Proposed Change RTS-171 to the Duane Arnold Energy Center Technical Specifications

The holders of license DPR-49 for the Duane Arnold Energy Center propose to amend Appendix A (Technical Specifications) to said license by deleting current pages and replacing them with attached, new pages. A List of the Affected Pages is given below.

The proposed change is required to reflect DAEC compliance with NUREG-0737, Item II.K.3.18.

TABLE 3.2-B (Continued)

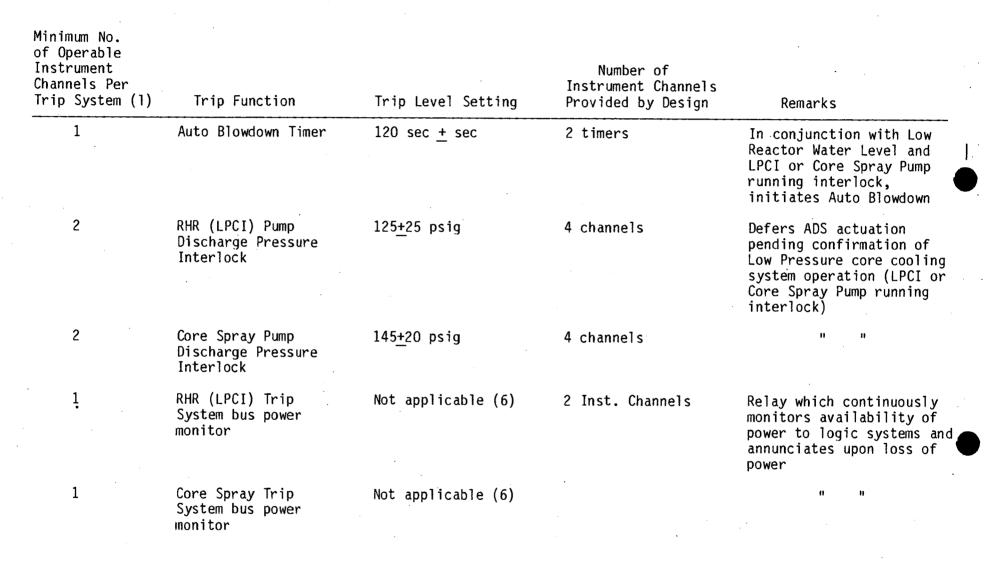
The Automatic Depressurization System (ADS) is initiated upon concurrent signals of high drywell pressure, low reactor water level, and a core spray pump or a RHR pump running. This ADS logic modification will eliminate the high drywell pressure permissive and will provide the capability to manually inhibit automatic depressurization.
